# UNITED STATES PATENT AND TRADEMARK OFFICE

APPLICATION NO.	FILING DATE	FIRST NAMED INVENTOR	ATTORNEY DOCKET NO.	CONFIRMATION NO.
10/729,410	12/04/2003	Michael Bret Hartmann	034043-002	9612

This is the first office action for application number 10/729,410, Illuminated Jack Stand, filed on December 4, 2003.

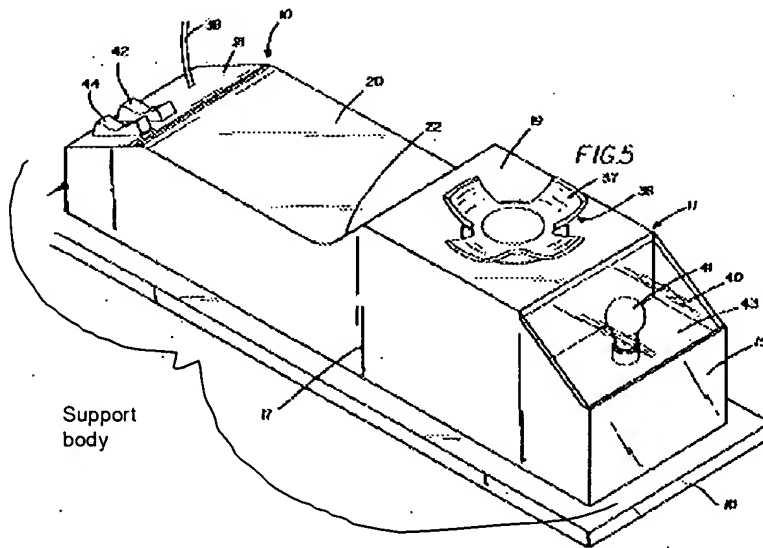
Claims 1-4 and 14 are rejected under 35 U.S.C. 102(b) as being anticipated by U.S. Patent number 5,992,826 to Simmonds.

Simmonds '826 discloses a jack stand (figure 5) comprising a support body (above), a vertically movable post (28,37) received within the support body, and a light source (41) mounted in the support body, wherein the light source is mounted in the body to illuminate at an upward angle from about 20-70 degrees

from the horizontal, and from about 40-60 degrees from the horizontal (with reference to figure 5, the light source clearly illuminates from approximately -45 degrees to the horizontal through about 180 degrees, so the above mentioned ranges are clearly satisfied), wherein the stand includes a mechanism (23, 27, 35, etc.) for controlling the vertical height of the vertically movable post with respect to the support body.

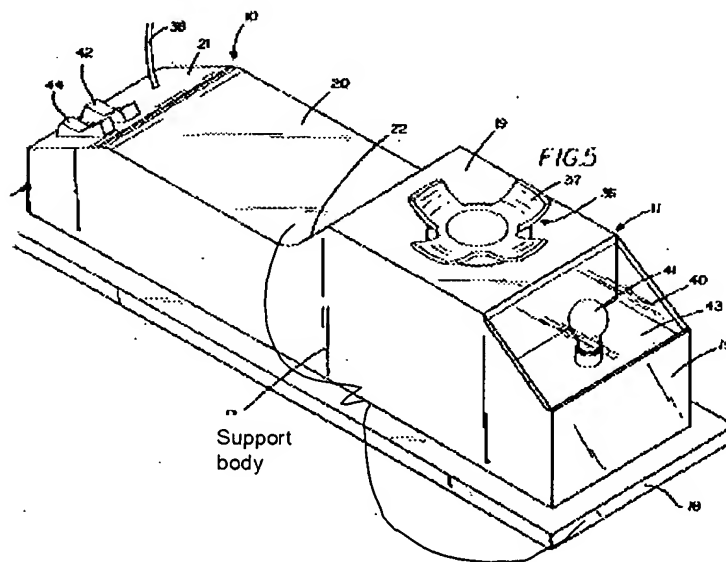
Regarding claims 7 and 8, Simmonds '826 teaches the previous invention wherein the light source is adjusted via a switch (42) mounted in the support

body, but fails to specifically divulge the switch to be an adjustable dimmer switch.

However, Camarota et al. '704 teaches the use of dimmer switch (page 2, paragraph 23) to dim a light source. It would have been obvious to one of ordinary skill in the art at the time the invention was made to have replaced the switch of Simmonds '826 with a dimmer switch as in Camarota et al. '704 since it is well known in the art that doing so can reduce electricity consumption in addition to allowing an operator to select a desired amount of illumination.
